APPLICATION NO.	FILING DATE	FIRST NAMED INVENTOR	ATTORNEY DOCKET NO.	CONFIRMATION NO.
09/749,677	12/28/2000	Masaki Okayasu	Q62316	8681

Office Action Summary

Non-Final Rejection

**FIG. 4**

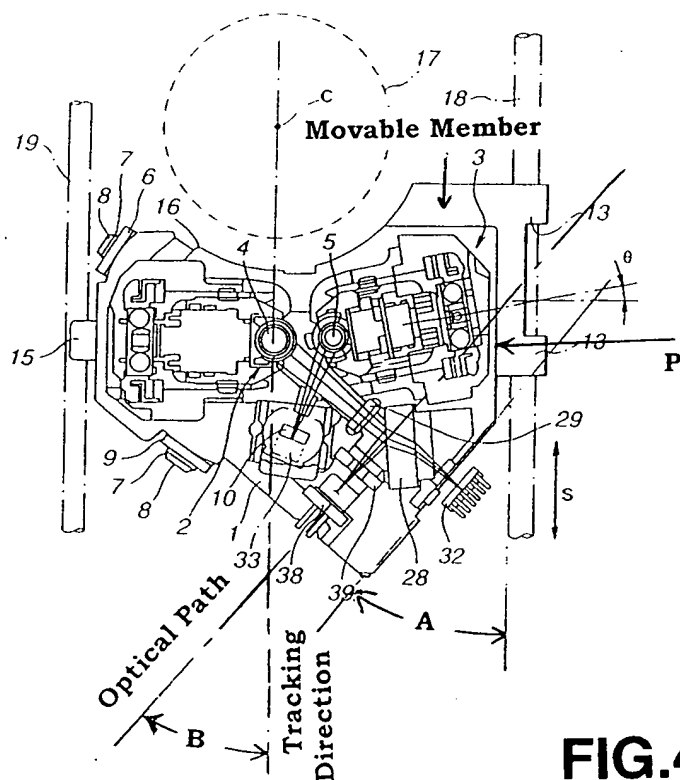
With regard to claim 1, Miike shows a mounting structure of a hybrid optical module in Fig.4 (a copy with added marks is attached in next page) including: a movable member (as marked) that is supported by two shafts 18 and 19, a recording medium drive apparatus shown in Fig 4 including a hybrid optical module 1 having a light emitting 38 (Fig. 4; column 13, line 14) and receiving device 32 (Fig. 4; column 14, line 31) mounted on the movable member, the hybrid optical module 1 being slid on the shafts 18 and 19 so as to perform a tracking operation on an optical recording medium (moving radially, column 6, lines 4-6), wherein a portion P of the hybrid optical module which is closer to one of the shafts 18 when the hybrid optical module is mounted on the movable member is cut out in substantially parallel with the shaft, and by an angle A which is substantially equal to an incident angle B of an optical path with respect to a tracking direction of the optical recording medium.

With regard to claim 2, Miike further shows that a spindle motor 17 (Fig. 4, column 6, line 12) is placed to be closer to the shaft 19 in a direction of light incidence of an optical system including the hybrid optical module, and the hybrid optical module having a cut portion P which is closer to another shaft 18 is mounted with a pick-up unit shown in Fig. 7.

With regard to claim 3, Miike further shows that the angle A by which the portion of the hybrid optical module is cut out is in a range of 30° to 45° substantially.
